OHIO TURNPIKE AND INFRASTRUCTURE COMMISSION

ADDENDUM NO. 2

**PROJECT NO. 39-18-01
MAINLINE PAVEMENT RECONSTRUCTION
MILEPOST 149.24 TO MILEPOST 154.10
LORAIN AND CUYAHOGA COUNTIES, OHIO**

MODIFICATIONS TO PLAN SHEET NOS. 14, 15, 22, 26, 58, 134, 135 AND 137

Project information: PROJECT 39-18-01, DATE: 09/22/17, ROADWAY SUB-SUMMARIES, REMOVAL, GUARDRAIL, EARTHWORK AND CURB, DESIGN AGENCY: GPD GROUP, INC., OHIO TURNPIKE AND INFRASTRUCTURE COMMISSION.

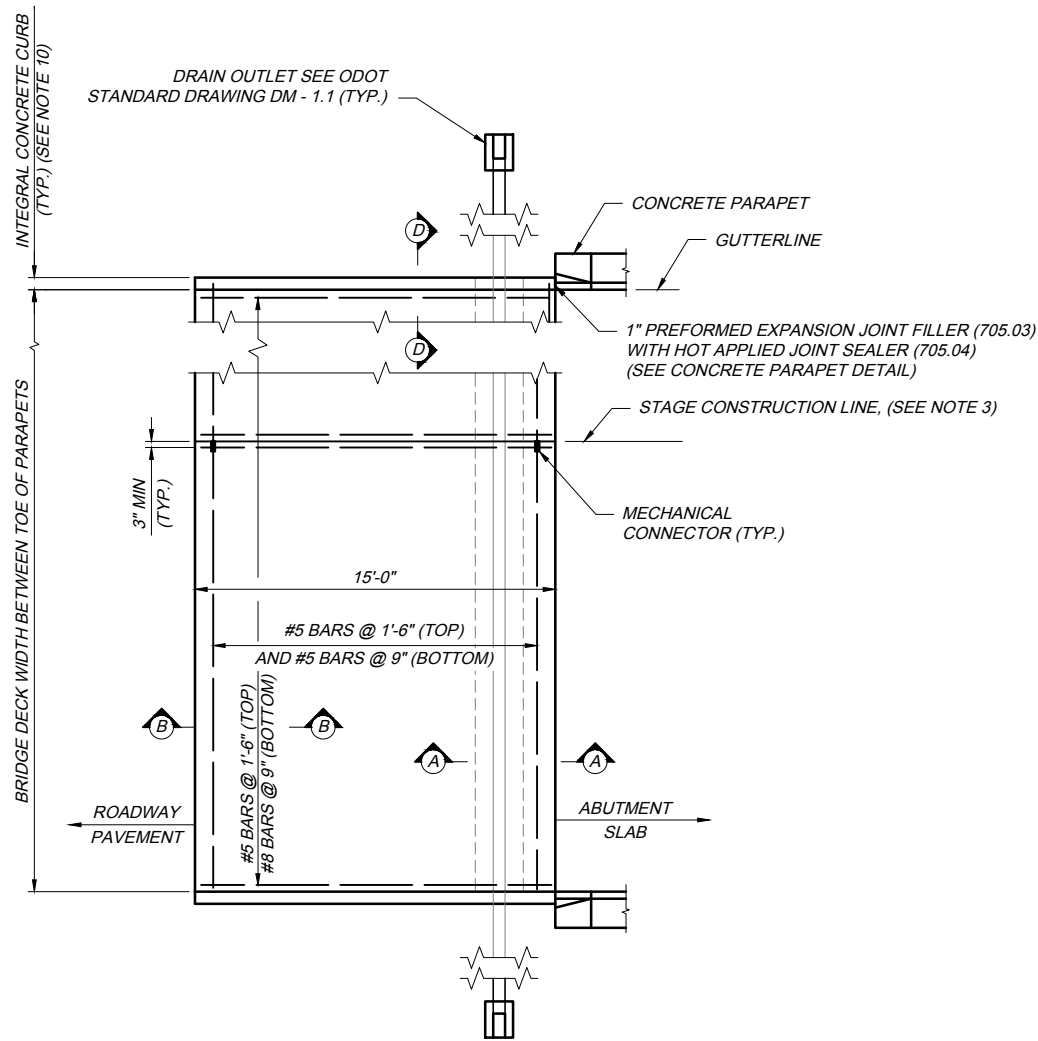
Q#28 Standard drawing CBR-1 does not show deducting any quantity of Concrete Barrier, B-50 through end anchors. However, the subsummary on sheet 137/393 deducts 15 ft of Concrete Barrier, B-50 through each end anchor. Will the Concrete Barrier, B-50 be measured and paid through the 15 ft end anchors in which case the end anchor item would be limited to the cost of the additional reinforcing steel?

Q#29 The notes on sheet 22 show median wall repairs occurring in phase 1. Per the subsummary on sheet 137/393, the only Concrete Barrier, B-50, As Per Plan is at the crossovers. If it is the intent to perform median wall repairs that are not currently accounted for please setup a separate item for this as the cost to pour back longer runs through crossovers is not comparable in scope to pouring back short repairs by hand.

A#28 The outer ends of the proposed Item 622 Barrier Misc.: Concrete Barrier, Type B-50, As Per Plan only requires expansion joints at the connection to the existing B-50 wall. Reinforced end anchorages are not needed. This Addendum No. 2 revises the quantity for Reference No. 43 – 622 Barrier Misc.: Concrete Barrier, Type B-50, As Per Plan to 730 FT and Removes Reference No. 44 – Barrier Misc.: Concrete Barrier, End Anchorage, Reinforced, Type B-50 for the Contract Documents. The quantities on Plan Sheet 134 and 137 of 393 are also revised.
